# PIC32MZ EF FAMILY

## PIC32MZ Embedded Connectivity with Floating Point Unit (EF) Family Silicon Errata and Data Sheet Clarification

The PIC32MZ Embedded Connectivity with Floating Point Unit (EF) family of devices that you have received conform functionally to the current Device Data Sheet (DS60001320), except for the anomalies described in this document.

**FIGURE 1: Posc CRYSTAL CIRCUIT**

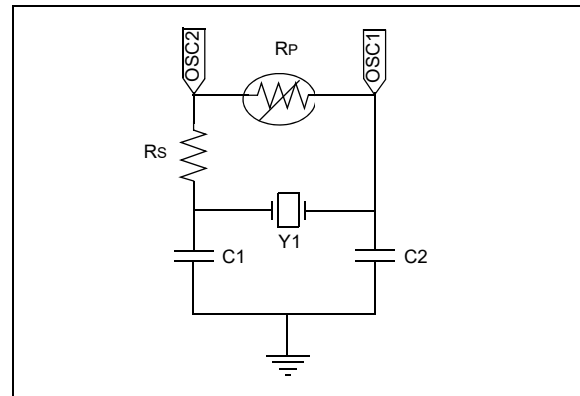
**Revision A1 Silicon:** A crystal oscillator cannot be used as an input to the Primary Oscillator (Posc) pins OSC1 and OSC2.

**Revision A3 and B3 Silicon:** The POSC has been tested in a normal power-up sequence and supports specific crystal operation.

The Primary Oscillator (Posc) has been characterized to operate at 8 MHz, 12 MHz, and 24 MHz when the circuit in [Figure 1](#) is implemented, and the operating conditions listed in [Table 3](#) are met.

- Note 1:** Using any other crystal frequency will require special component selection and characterization.  
**Note 2:** A parallel resistor (Rp) should not be used to increase the gain of the POSC.

### 64-PIN QFN<sup>(4)</sup> AND TQFP (TOP VIEW)

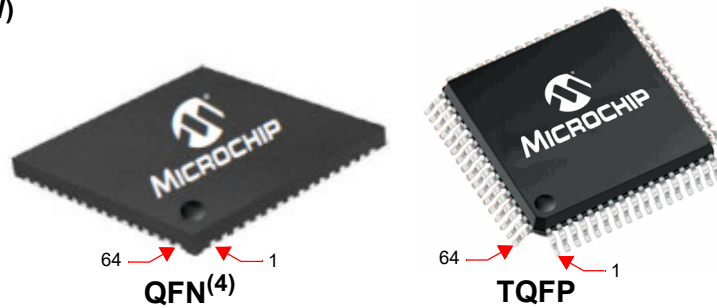
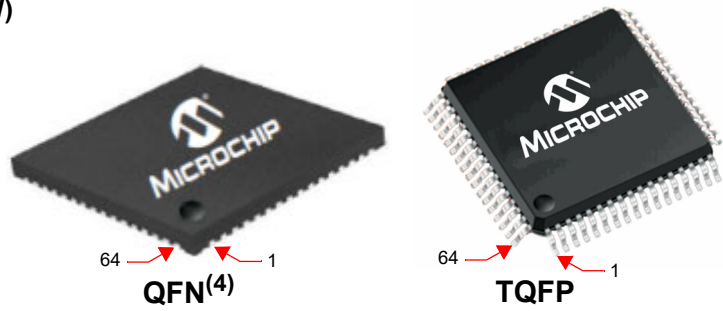
In Table 2. “Pin Names for 64-pin QFN and TQFP Devices” of the current data sheet, the AECRS<sub>DV</sub> signal was erroneously omitted from the pin number 44 and added to the pin number 62. The correct assignment is shown in bold type in the following table.
